Access Compliance Report

Public Rights-of-Way

Intersection ID: 47035	Main Street: W_ARROWOOD_RD	Cross Street: STONEGROVE_LN	Location: SW
ADA ID: 28FA42F88297	Ramp Type: BlendTrans1	Initial Pass/Fail: Pass	Overall Compliance: No
Severity Score: 2.5			
Codes/Mitigation Info/Possible Solution		Field Measurements/Component Compliance

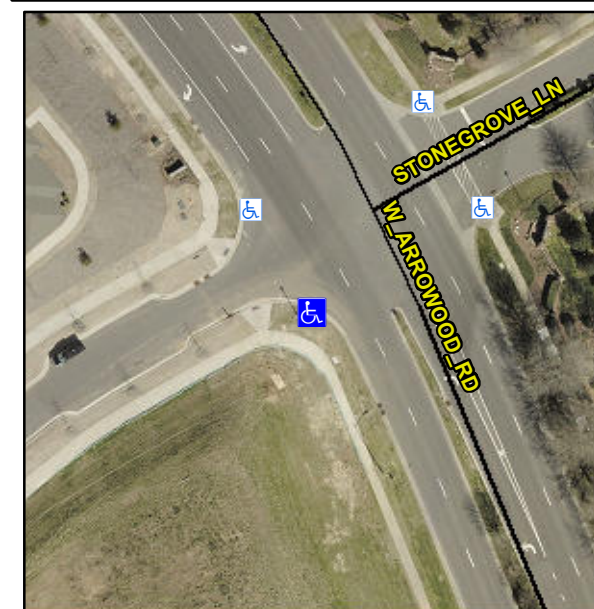
Not Found, R304.2.2-Perp, R304.3.2-Para, R305.1.4, R305.2, R304.5.3

Compliance	Description	Data	Compliance	Description	Data
N/A	Ramp Length (in)	159.5	Yes	BlendTrans Slope (%)	5.0
Yes	Ramp Width (in)	60.0	Yes	BlendTrans XSlope (%)	1.8
N/A	Flare Type LT	Sloped	N/A	Flare Type RT	Sloped
N/A	Flare Slope LT (%)	5.6	N/A	Flare Slope RT (%)	6.7
N/A	Flare Traversable LT?	No	N/A	Flare Traversable RT?	No
Yes	Landing Length (in)	95.0	Yes	DWS Provided?	Yes
Yes	Landing Width (in)	62.0	Yes	DWS Contrast?	Yes
No	Landing Slope (%)	2.1	Yes	DWS Length (in)	24.0
Yes	Landing X Slope (%)	0.1	No	DWS Full Width?	No
N/A	Landing Curb? (Y/N)	No	No	DWS Offset (in)	5.0
N/A	Shared Landing?	No			
Yes	Gutter Ponding?	No	Yes	Gutter Slope (%)	0.9
Yes	Gutter Lip Ht (in)	0.0	No	Gutter X Slope (%)	2.1
N/A	Painted X Walk1?	No	N/A	Painted X Walk2?	N/A
	X Walk 1 Direction	To NW		X Walk 2 Direction	N/A
	X Walk 1 Width (in)	N/A		X Walk 2 Width (in)	N/A
	X Walk 1 Slope (%)	1.5		X Walk 2 Slope (%)	N/A
	X Walk 1 X Slope (%)	2.7		X Walk 2 X Slope (%)	N/A

N/A	Ramp inside XWalk1?	N/A	N/A	Ramp inside XWalk2?	N/A
	Road Slope (%)	2.7		Clear Space?	Yes
	Road X Slope (%)	1.5	N/A	Clear Space to XWalk (in)	N/A
Yes	Any Obstructions?	No	Yes	Storm Grate/Utility Hazard?	No
	Obstruction Type			Storm Grate/Utility Type	
		N/A			N/A
			Yes	Surface Condition? (G/P)	Good
			No	Curb Slope (%)	10.0

Remove & Replace Curb Ramp With Two New Directional Ramps or Equivalent. Remove & Replace Gutter.
